Smith Ranch-Highland
Operation

**RE: Response to East Storage Pond Leak, Review of January 2012 Report
Permit 633, Cameco Resources (Wellfield Release Volume)**

**Response to East Storage Pond Leak, Review of January 2012 Report
Permit 633, Cameco Resources**

Smith Ranch Storage Ponds Investigation Work Plan

**FIGURE 1
PROPOSED TEST PIT
AND BOREHOLE LOCATIONS**

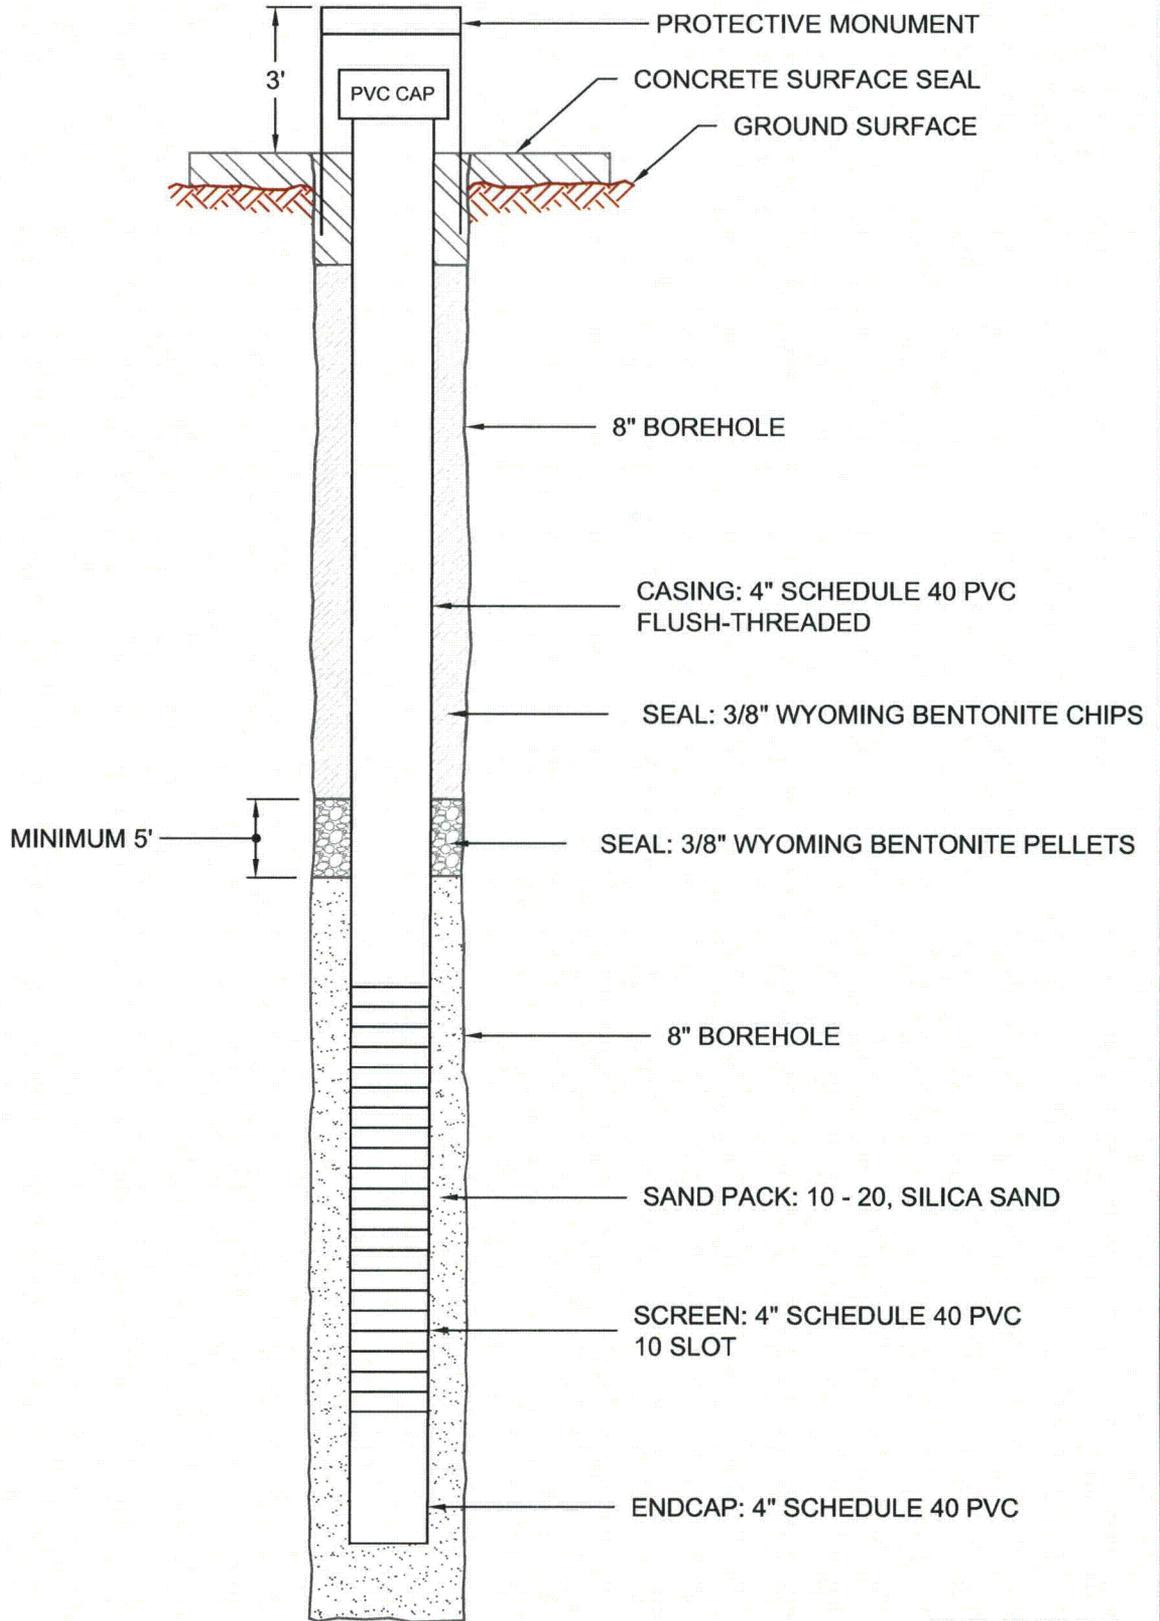
2. *Due to the numerous leaks in the storage ponds over the last 22 or more years, LQD is concerned that seepage from the ponds may be creating a plume of contaminated groundwater. During the November 2011 inspection, CR discussed possible installation of monitor wells around the ponds to monitor the water quality and the potential of a plume. LQD requests CR submit a plan for investigating potential groundwater contamination as a result of the high number of leaks at the ponds. Please provide a plan to investigate seepage from the ponds to shallow groundwater within 90 days of receipt of this letter. (SI/PCR)*

However, there is poor resolution of lithology and saturation information in the uppermost 30 feet of the available borehole geophysical logs. The work plan is designed to ascertain both subsurface lithology and the presence or absence of saturated conditions above the shale unit (within 50 feet below ground surface) using test pits and drilling operations. The proposed locations of test pits and boreholes are presented on Figure 1.

Drilling and subsequent well installation will be conducted following the test pit excavation. A total of three boreholes are proposed for the locations identified in Figure 1. These boreholes will be located near the test pits in the anticipated down gradient direction from the ponds (west, south, and east), and will terminate at the top of uppermost-shale unit. A qualified geologist will be on-site to log the lithology in each borehole, identify saturated conditions, and determine the total depth of the borehole

Cameco Response: See the Smith Ranch Storage Ponds Investigation Work Plan attached.

An excavator or backhoe is proposed to excavate six test pits within the vicinity of the pond. The purpose of these test pits is to determine if seepage is occurring into the shallow subsurface from the ponds. Test pits will be excavated to a minimum depth of ten feet or until refusal or equipment limits. Test pit sidewalls will be logged by geologist, photographed, and left open for 24 hours. After 24 hours, the excavation will be photographed, the presence or absence of water documented and the pits backfilled. Water that accumulates in the test pits will be sampled remotely.
